Accessibility Audit Report

Institute of Home Economics

University of Delhi

1.07.2026

Canteen and outdoor seating area

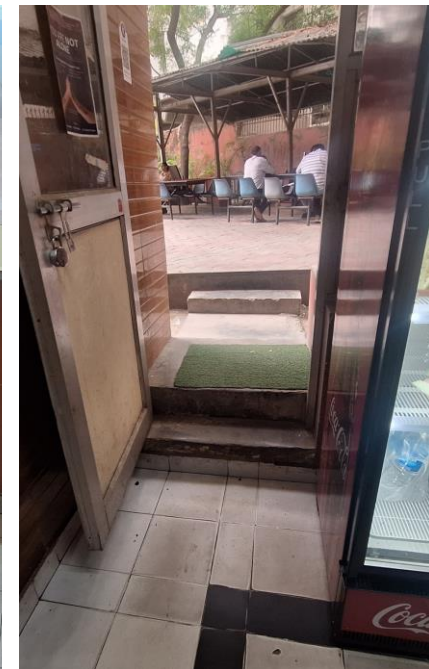
- TGSi is missing in front of the door .
- Trip hazard in front of the canteen.
- Doors use heavy glass panels with tight clear openings (720 mm).
- High service counter (720 mm high, 380 mm deep).
- Additional floor level threshold step of +170 mm at the exit connecting the outdoor eating space.
- Pantry is placed directly opposite narrow structural corridors, causing physical bottlenecks when appliance doors or cabinet units are opened.

- Ramp to be provided to merge the gap.
- Refer page no. 38.
- Provide TGSi for connecting are more than 3 m wide.

Ladies Toilet (Staff only) – Ground floor level

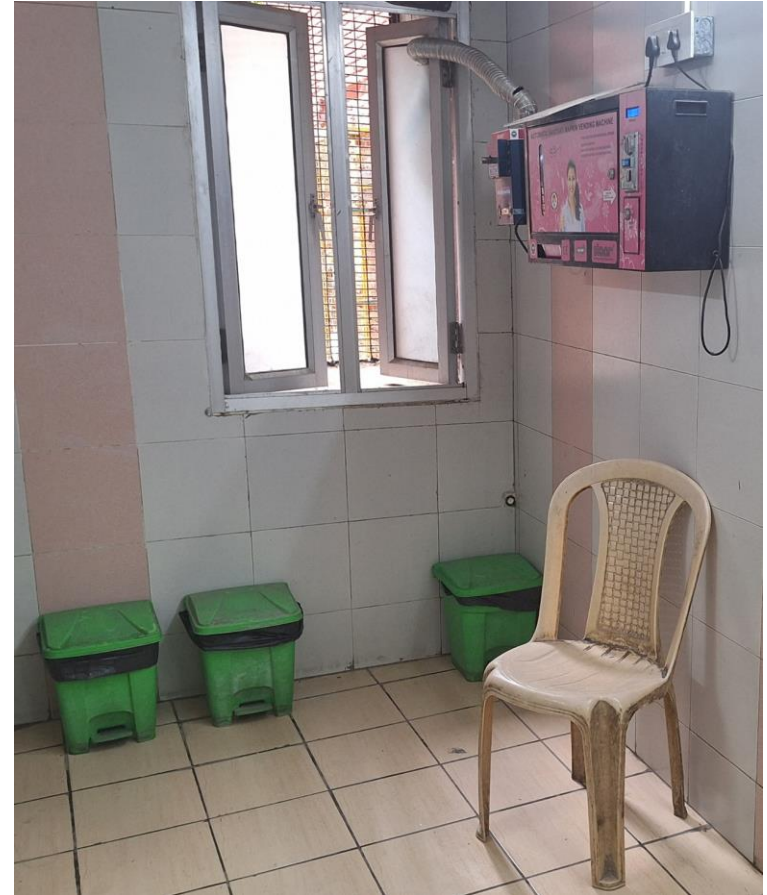
- The size of the **All Gender Toilet** is 1377mm x 3178mm.
- Door opening outside.
- There is no emergency call button inside.
- Grab bars shall be improved.
- There is no washbasin inside the toilet.

Ladies Toilet (Second floor) – staff only

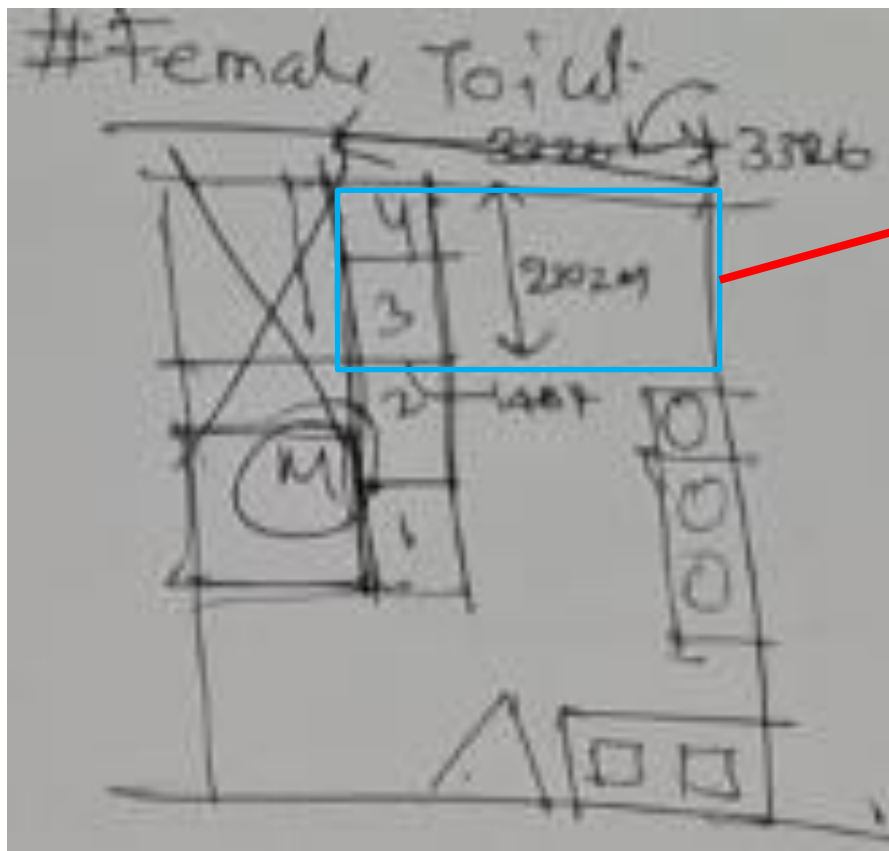
- Only 'mirror room' is provided in the space of all gender accessible toilet.
- There are 3 washbasins and 4 cubicles with western closets are provided.
- **One low level accessible washbasin shall be provided.**
- Toilet is in deteriorated stage. Renovation is in progress as per staff information.

- Cubicle 3 and 4 with the space at the front shall be recommended to create All Gender Accessible Toilet.
- Size available is 3326mm x 2102mm.
- One low level accessible washbasin shall be provided.

Ladies Toilet (Third floor)

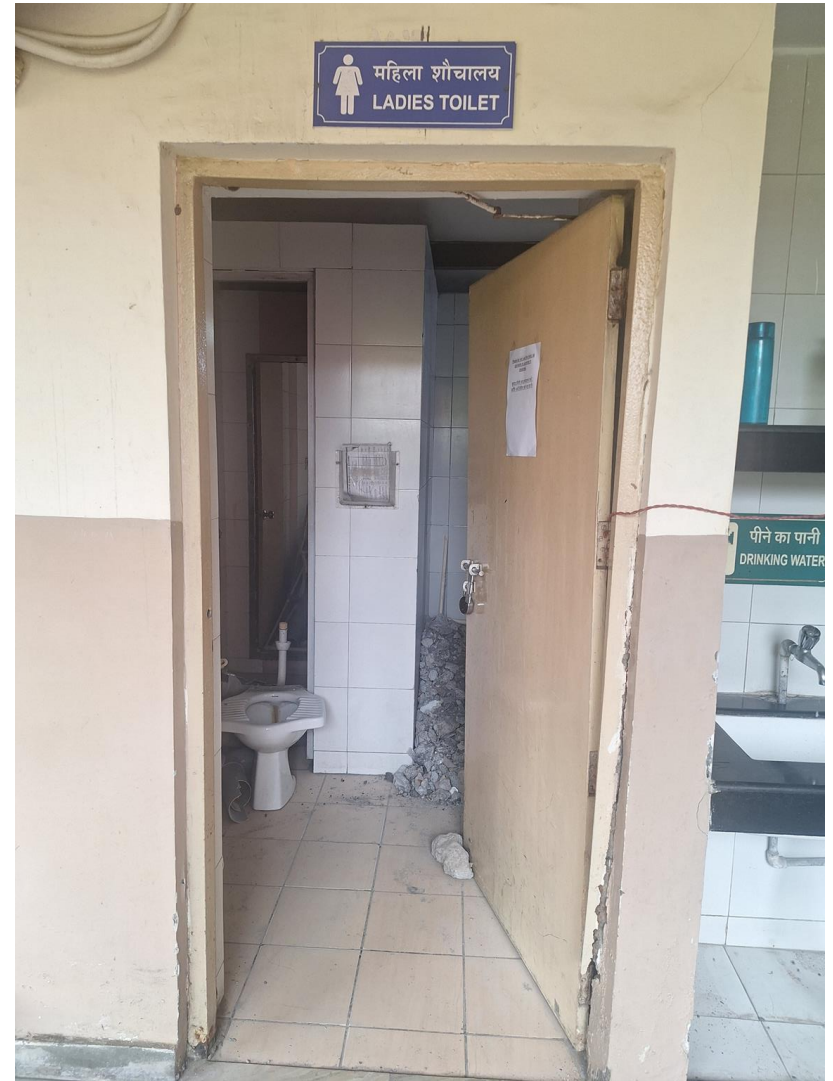
- Toilet under renovation.

Signages

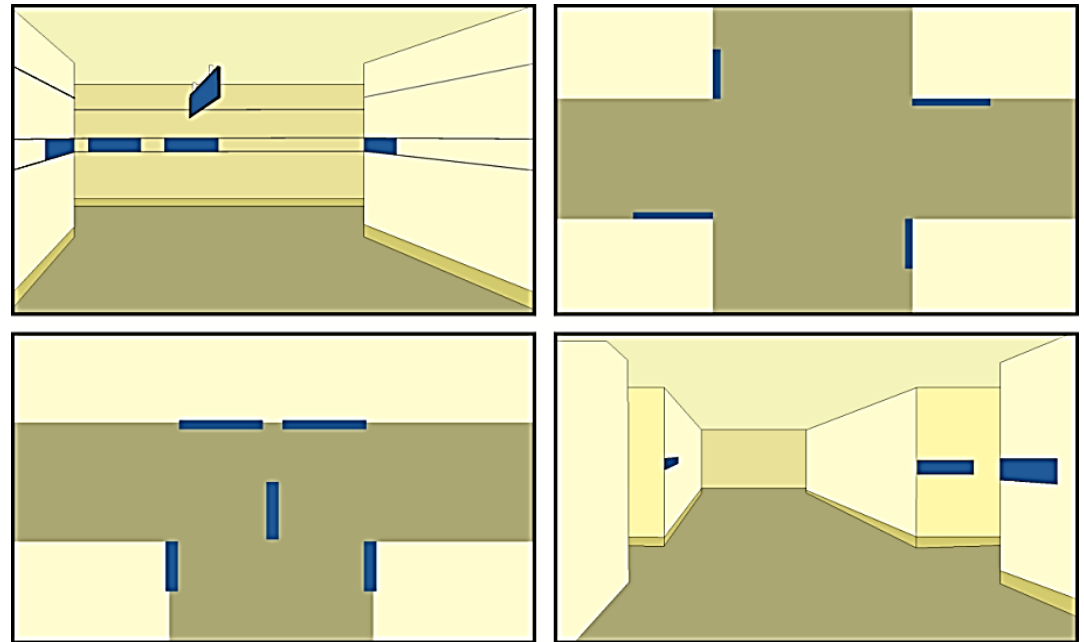
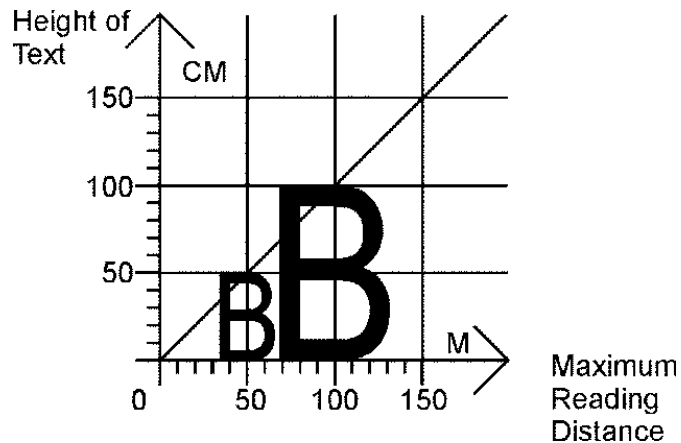
- Signage for ladies toilet shall be improved.
- Waf finding signage with list of rooms is provided in the wall opposite to the lift at third floor.

Preparation Room (only for staff)

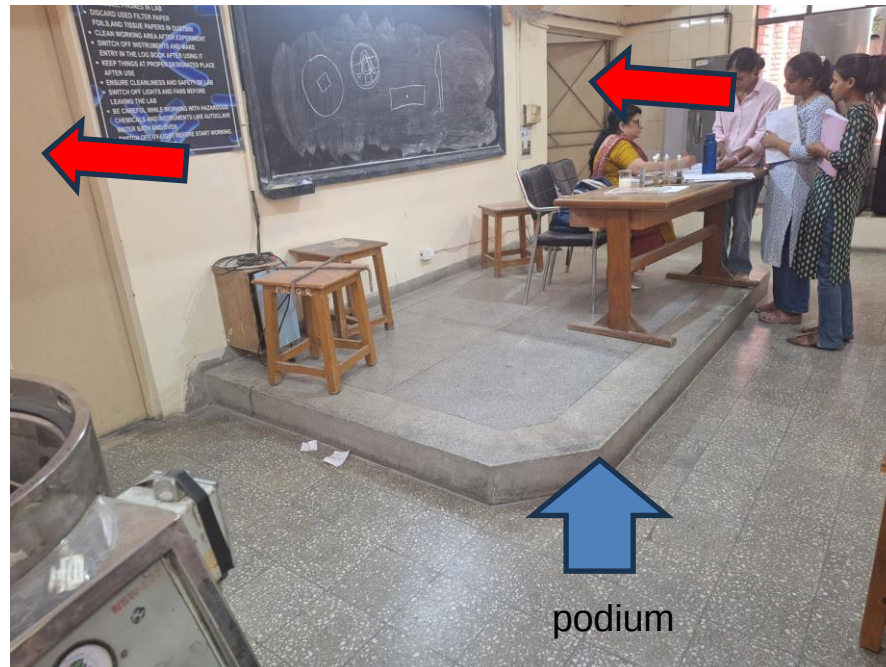
- Low level sink or adjustable counter is missing.

Printing shop

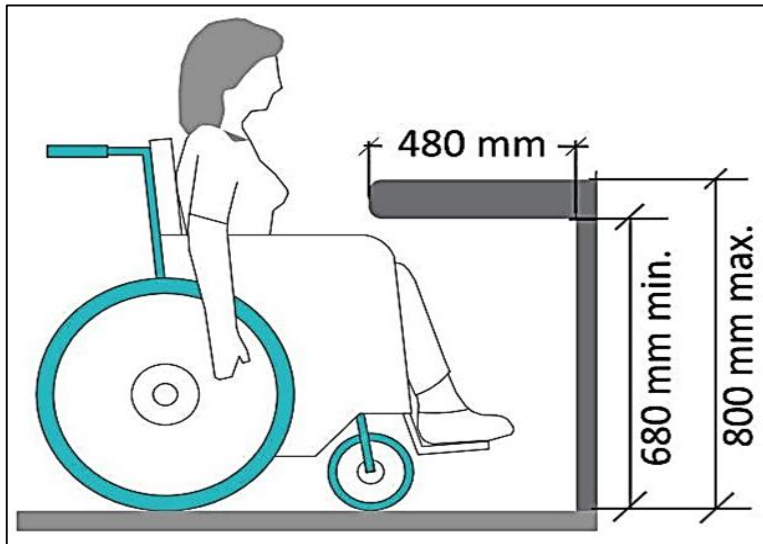
- Printing shop accessories are extended outside the shop and spread-out in the corridor space.
- **There shall be no obstructions in the accessible path.**

Library

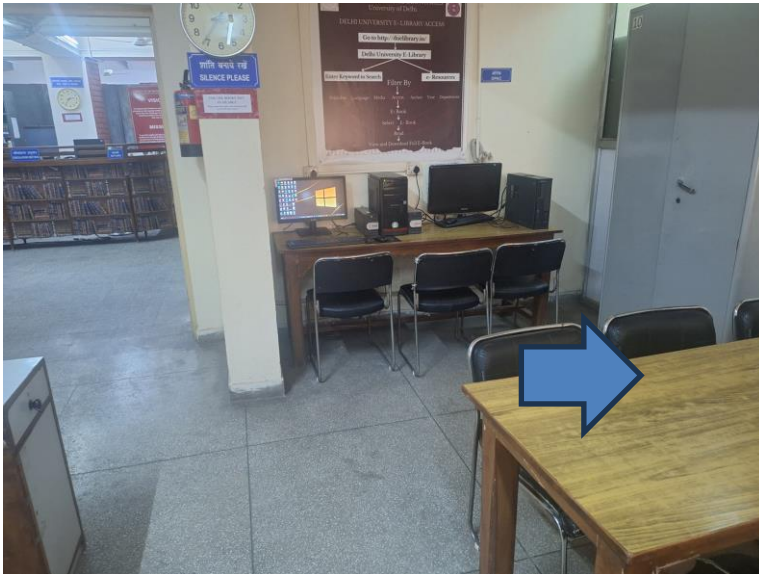
- Distance between two stack area is minimum of 904mm and maximum of 1367mm.
- Signage for locating books are fixed perpendicular to the passage.

Theory rooms (Audited room no. 117)

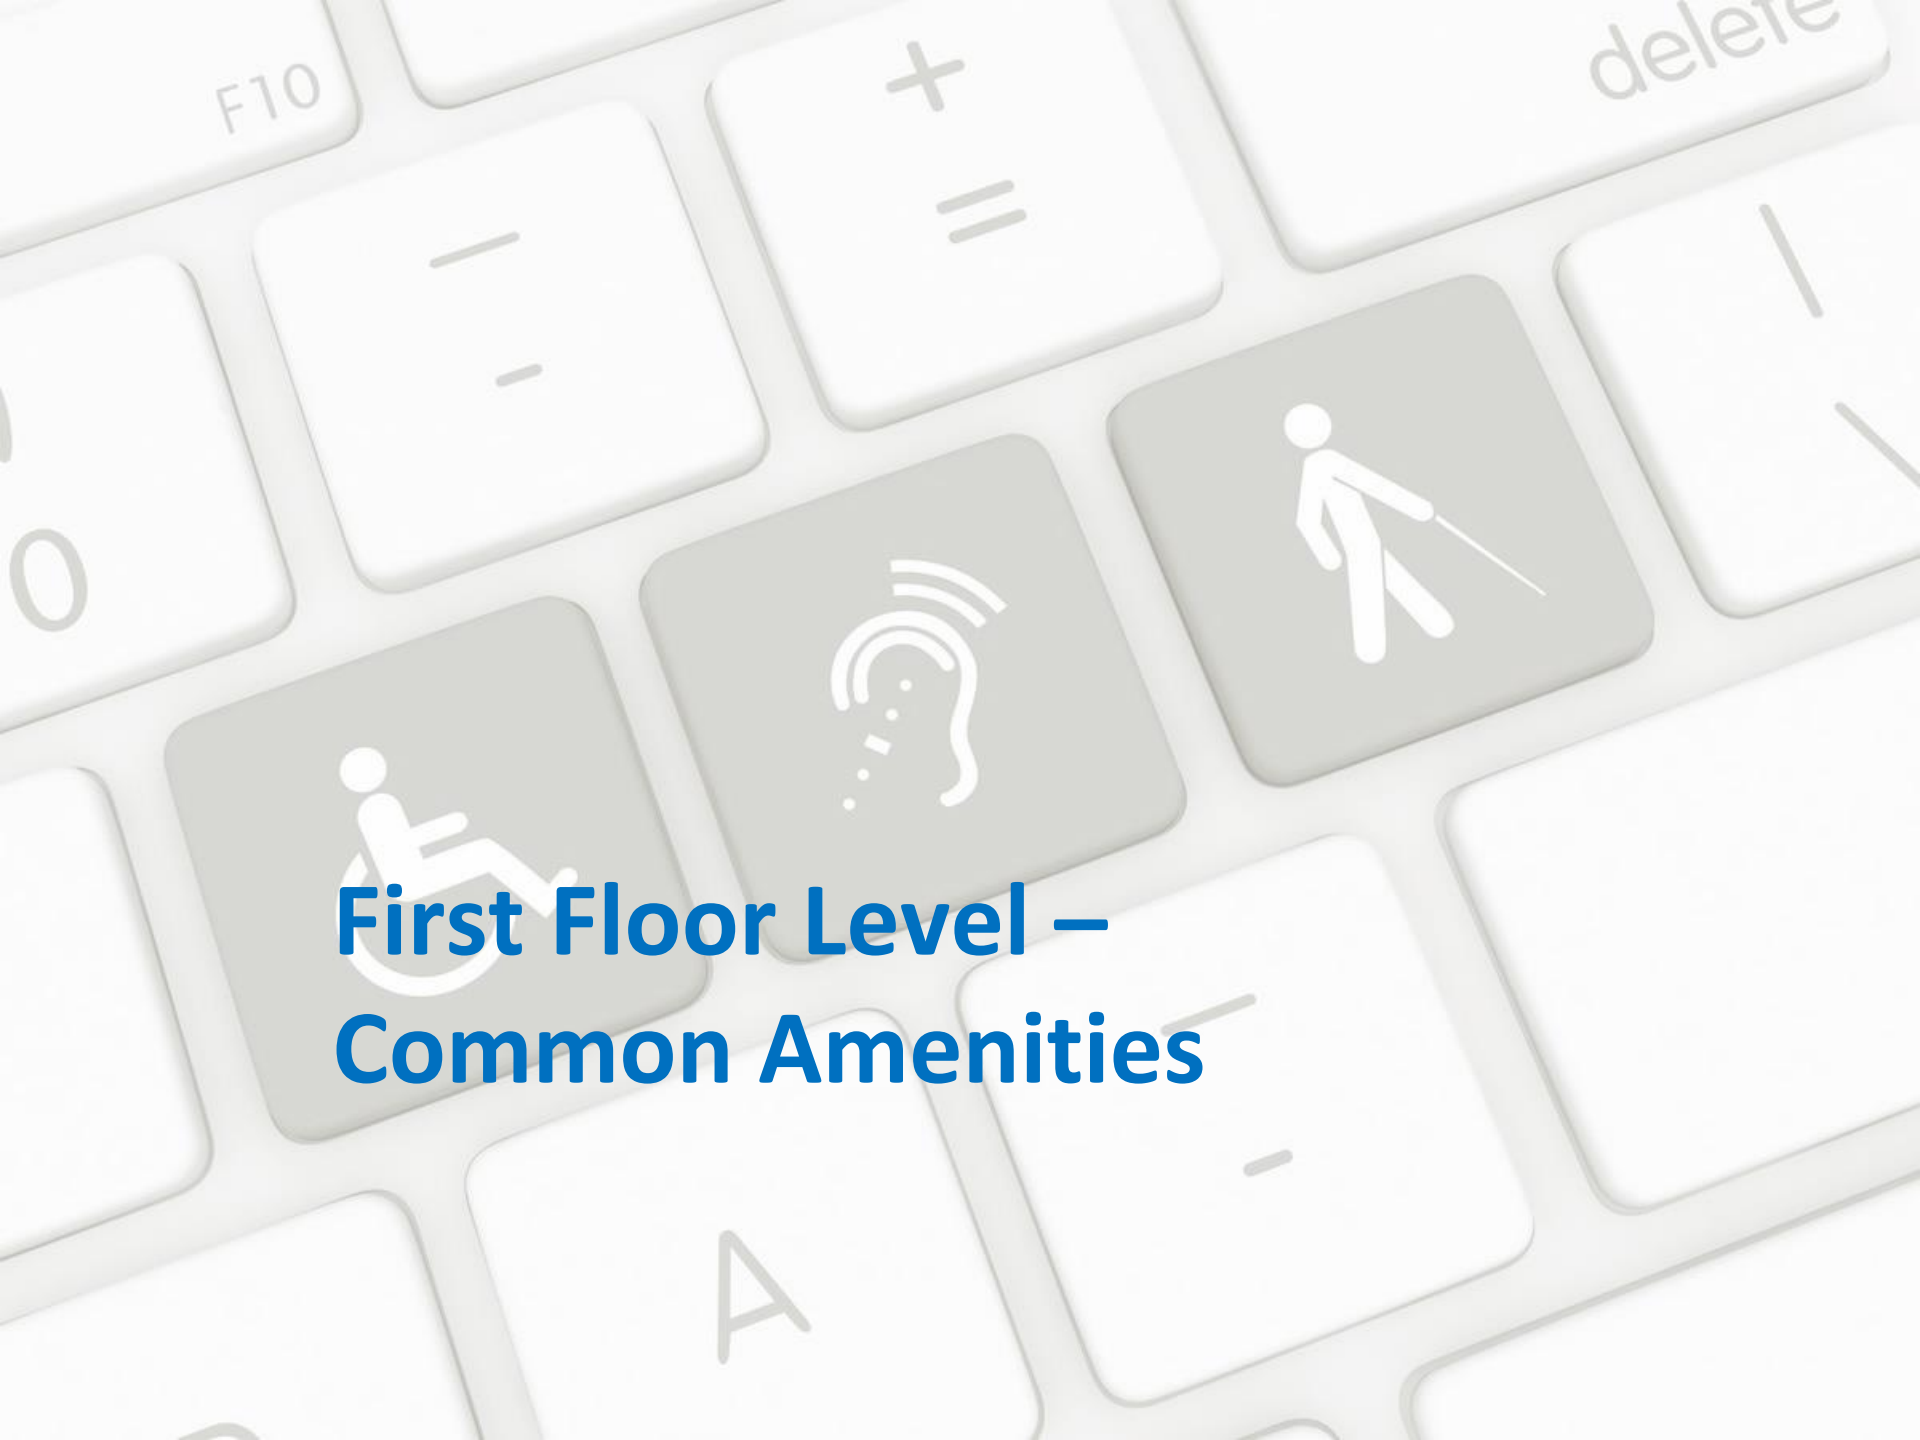
- Door with double shutter is provided to enter the theory room.
- However there is a level difference due to new flooring with ceramic tiles. **Bevelled edge shall be provided to have smooth transition for person using wheelchair.**
- There is no stage/podium for lecturer. Hence, there is enough space to accommodate reserved seating area for wheel chair users in the first row close to the teaching board.
- However, high-level platform/stage access requires traversing 6 steps without an accompanying ramp option.
- There are provision of 2 doors to the theory room. One at the level of the corridor and an another at the last step height inside the theory room with a flight of stairs to exit from the rear side.

Dept. of Physical Education

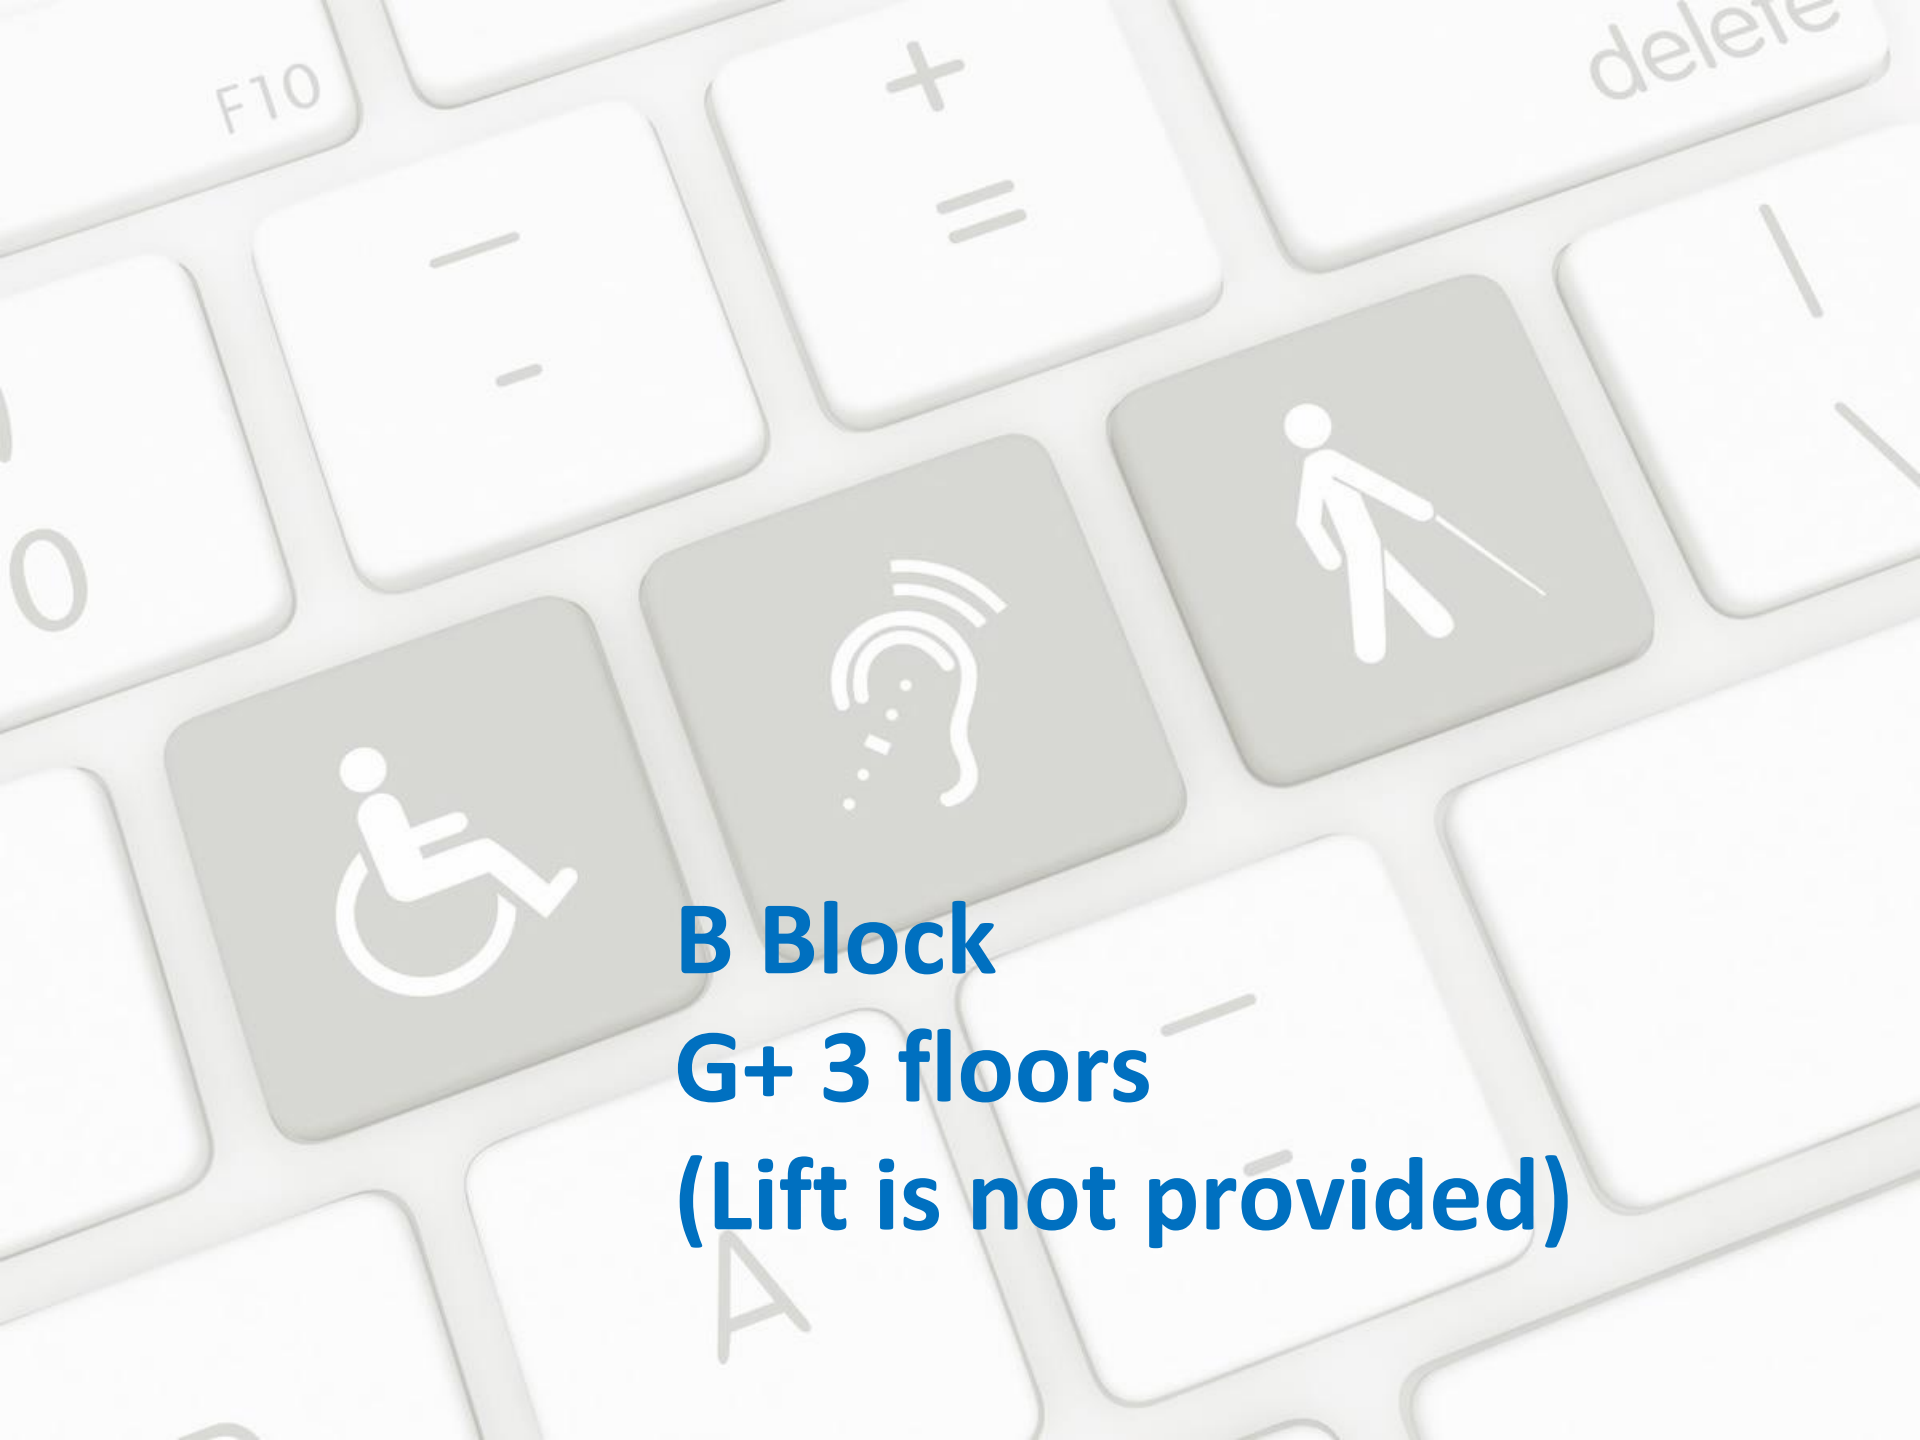
- Bevelled edge shall be provided at the entry to multipurpose room. There is raise of 50mm due to new flooring from the corridor space.
